London Borough of Croydon Complaint Ref: CAS-163554-V7D4M9.
Planning Approval Ref: 19/04705/FUL; 16-18 Ash Tree Close Croydon CR0 7SR.
Escalation to the Local Government Ombudsman.

Please consider this letter as a formal **Complaint** against the approval at London Borough of Croydon Planning Committee Meeting of **27th February 2020** for **Planning Application Ref: 19/04705/FUL; at 16-18 Ash Tree Close, Croydon, CR0 7SR** – for Demolition of the existing dwellings. Erection of 8 dwellings with associated access, parking, refuse and cycle stores (amended Plans). This Complaint has been through the Local Council's Stage 1 & 2 process.

Envirioment Agency Flood Map for locality which shows close proximity to High & Medium risk of flooding from the Chaffinch Brook.

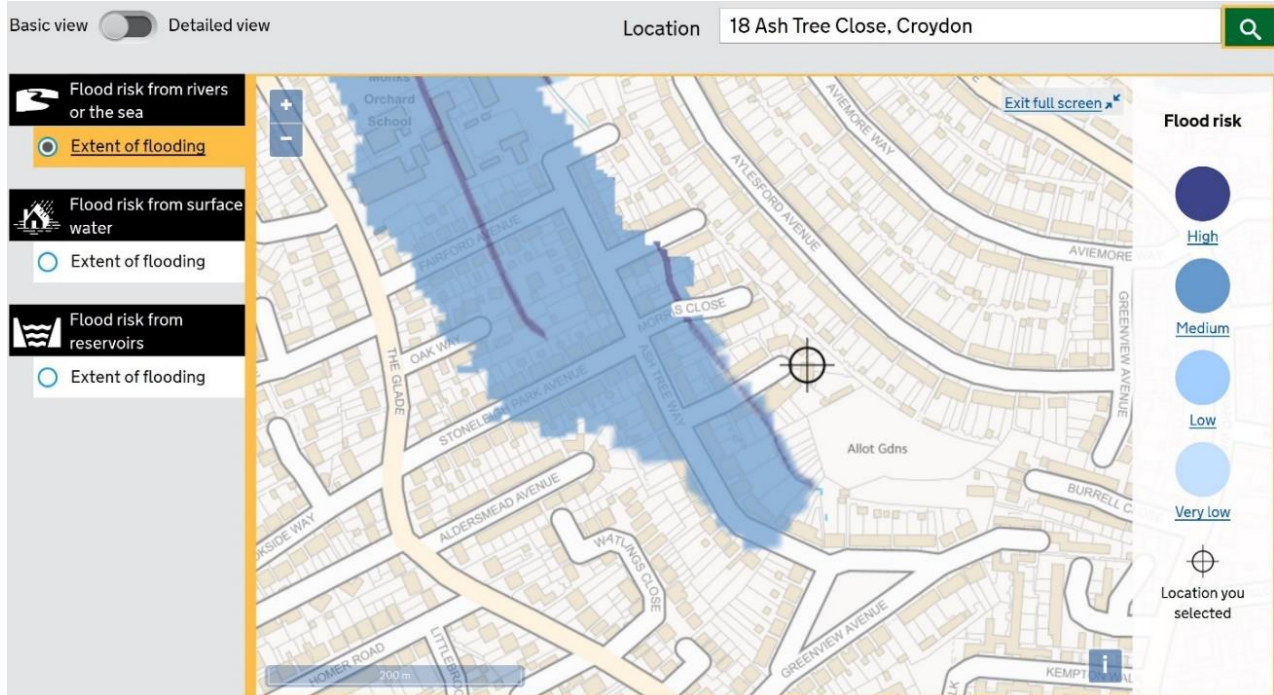
Ms. Mustafa in her Stage 2 response states *"The application site lies in a Flood Zone 1 which is the lowest category of flood area..."* However, the environment agency flood map (see below) indicates the application area is very close to medium and high risk of flooding and that the loss of the developed area to absorb precipitation and surface water due to the development and from the loss of vegetation and absorption due to construction will contribute to a higher probability of increased flooding locally and increased probability of flooding further downstream of the Chaffinch Brook; including Stoneleigh Park Avenue, Oak Way, Fairford Avenue and Ash Tree Close.

This Histogram shows recent planning approvals; Residential Densities appropriate requirements for available PTAL and the actual required PTALs, Trending to PTAL 5

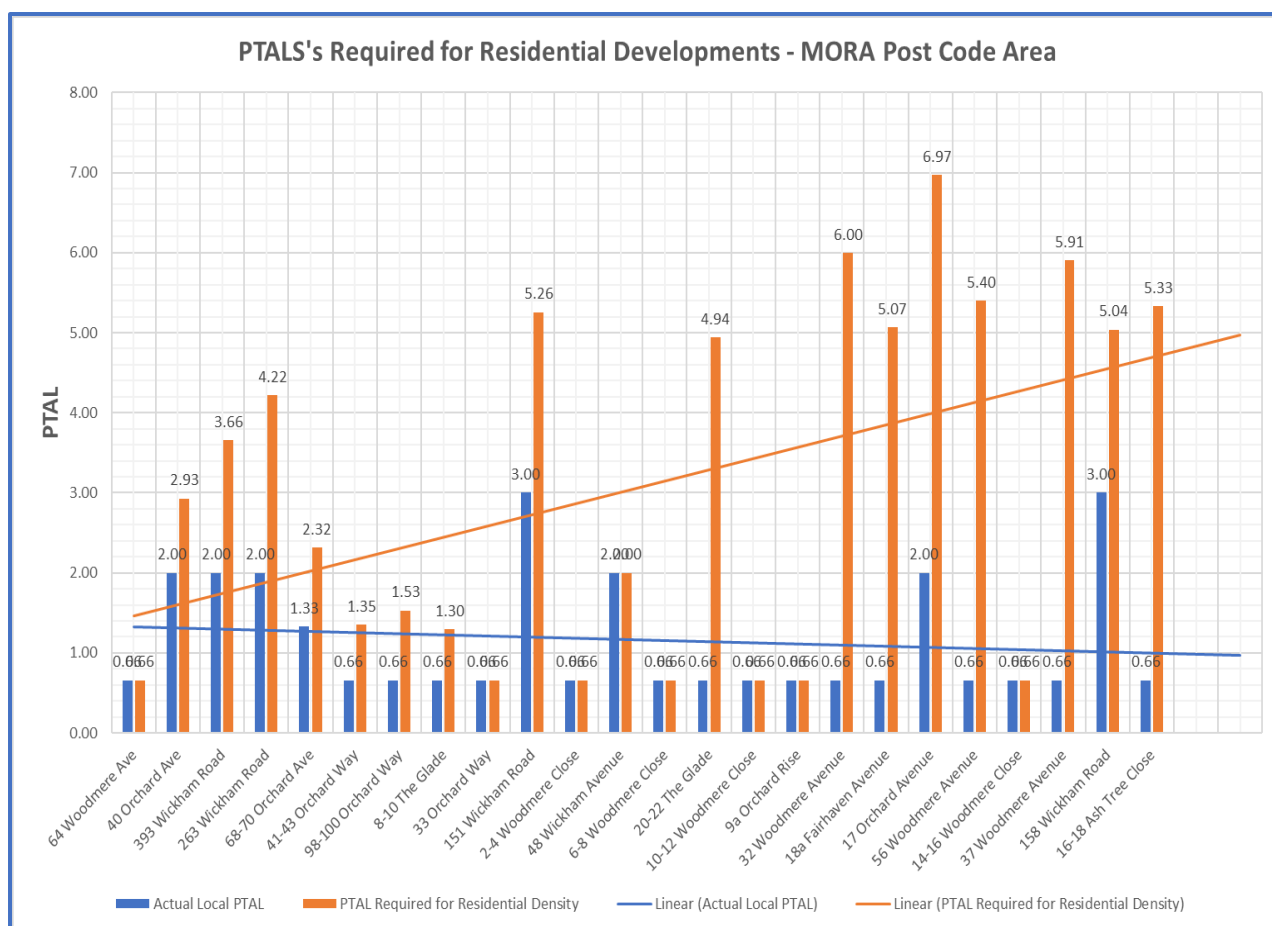
It is appropriate at this juncture to highlight the effect of recent in-fill and re-developments in the MORA Post Code Area as illustrated in the histogram below; a number of which have been the subject of MORA complaints to the Croydon LPA and Complaints to the LGO, but which the LGO have declined to further investigate due to lack of residents' consent. (As it affects all our members and residents). See: <http://www.mo-ra.co/planning/planning-complaints/>

In summary, we have proved that the cumulative effect of recent approvals for just the MORA Post Code area significantly exceeds the appropriate Residential Densities as does this approval for 16-18 Ash Tree Close and that the data provided by Ms. Mustafa in her stage 2 response is 'Highly Suspect'.

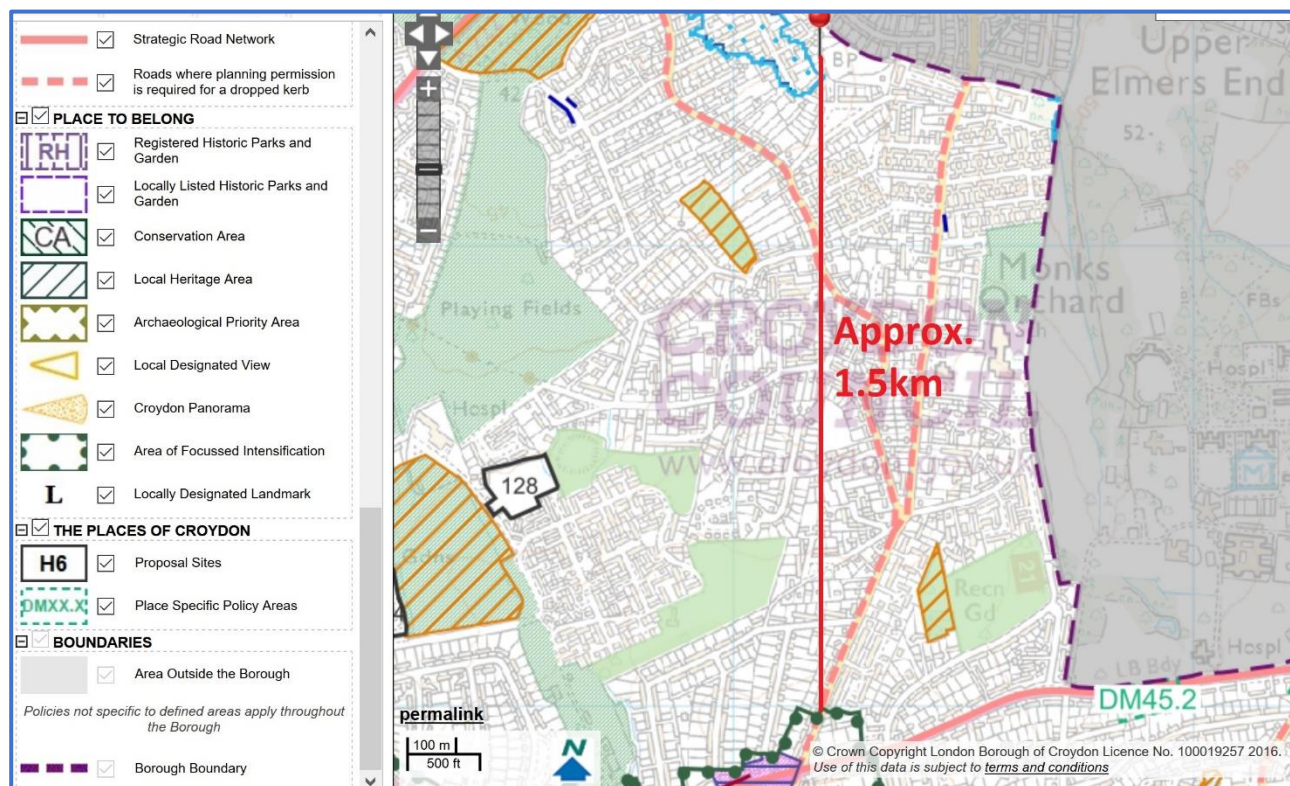
The Ordinance Survey Map provided by the applicant only shows the local vicinity to give members an idea of the actual locality of the proposed development in relation to the surrounding locality and does not indicate the distance to the nearest “Intensification” area. We therefore challenge Ms. Mustafa’s statement.

Plot 2 Parking Bay Egress

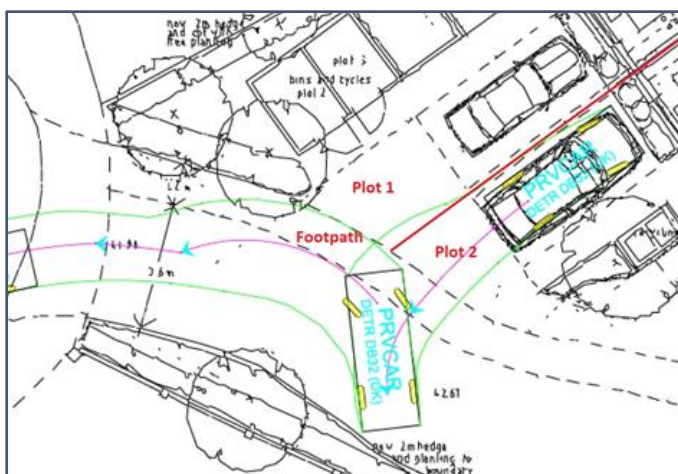
The Swept path diagram for Parking Bay **Plot 2** indicates the difficulty exiting the parking bay in reverse gear in order to exit the driveway in a forward gear into Ash Tree Close roadway.

The new swept path diagram shows that it is necessary to encroach over the curtilage of **Plot 1** Forecourt and then necessary to change into a forward gear and mount the access footpath in front of **Plot 1** in order to exit in a forward gear into Ash Tree Close.

The future occupants of **Plot 1** would likely object to this necessary manoeuvre for the life of the development as an inconvenience which could cause conflict for the life of the development. The owner occupier of **Plot 1 or 2** may wish to erect a **boundary fence** to extend to the footpath in order to define the **curtilage of their responsibility** and maintenance which would prevent further manoeuvres of egress of a forward parked vehicle from exiting **Plot 2** Parking Bay.

Plot 3 Parking Bay Egress

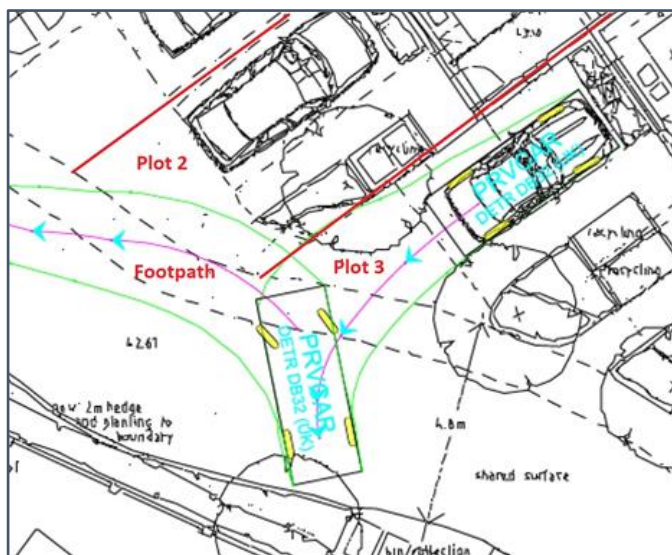
The Swept path diagram for Parking Bay **Plot 3** indicates the difficulty exiting parking bay in reverse gear in order to exit the driveway in a forward gear into Ash Tree Close.

The new swept path diagram shows that it is necessary to encroach over the curtilage of **Plot 2** Forecourt and then necessary to change into a forward gear and mount the access footpath in front of **Plot 2** in order to exit in a forward gear into Ash Tree Close.

The owner occupier of **Plot 2** may wish to erect a **boundary fence** to extend to the footpath in order to define their **curtilage of responsibility** and maintenance which would prevent further manoeuvres of egress of a forward parked vehicle from exiting **Plot 3** Parking Bay.

Plot 6 Parking Bay Egress

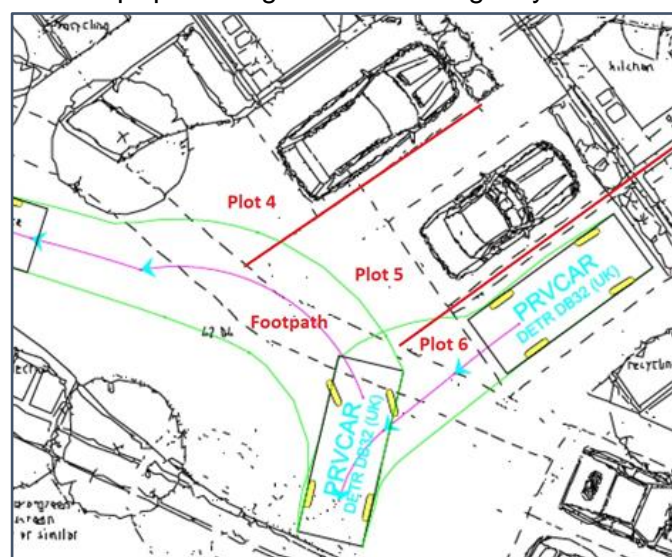
The Swept path diagram for Parking Bay for **Plot 6** indicates the difficulty exiting parking bay in reverse gear in order to exit the driveway in a forward gear into Ash Tree Close roadway

The owner occupier of **Plots 4 & 5** may wish to erect a **boundary fence** to extend to the

footpath in order to define the **curtilage of their responsibilities** and maintenance which would prevent further manoeuvres of egress of a forward parked vehicle from exiting **Plot 6** Parking Bay.

Plot 7 Parking Bay Egress

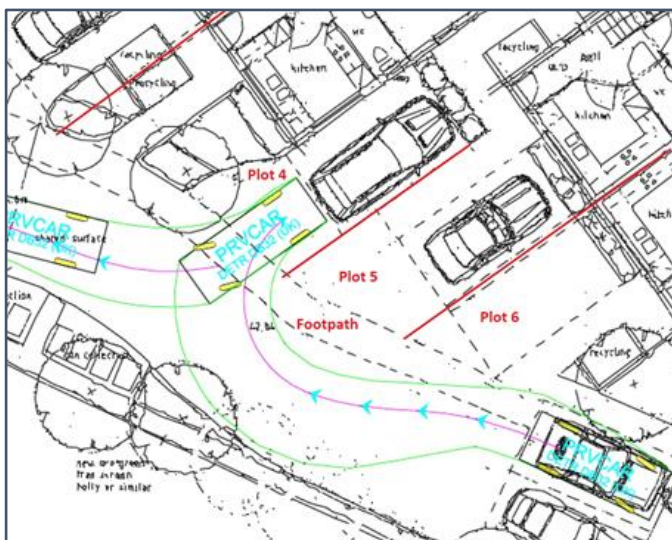
The Swept path diagram for Parking Bay **Plot 7** indicates the difficulty exiting parking bay in reverse gear in order to exit the driveway in a forward gear into Ash Tree Close roadway. The new swept path diagram shows that it is necessary to mount the footpath and encroach into the forecourt within the curtilage of **Plot 4** in a reverse gear before engaging a forward gear, mounting the access footpath in front of **Plot 4** in order to exit in a forward gear into Ash Tree Close.

The future occupants of **Plot 4** would likely object to this necessary manoeuvre for the life of the development as an inconvenience

Plot 8 Parking Bay Egress

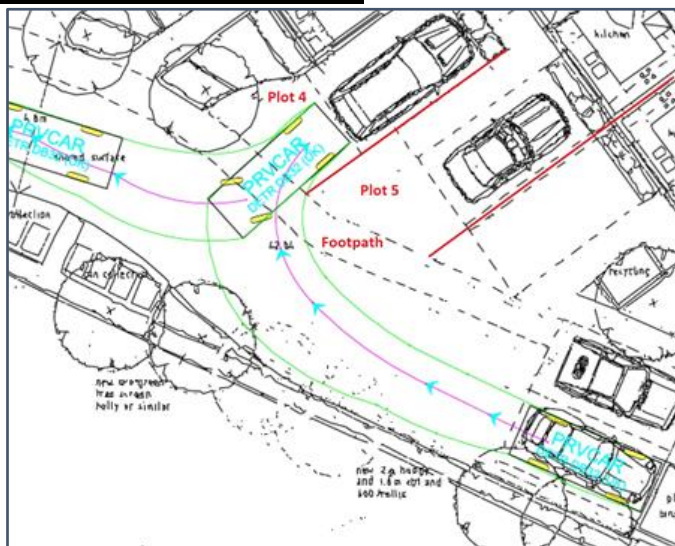
The Swept path diagram for Parking Bay **Plot 8** indicates the difficulty exiting parking bay in reverse gear in order to exit the driveway in a forward gear into Ash Tree Close roadway.
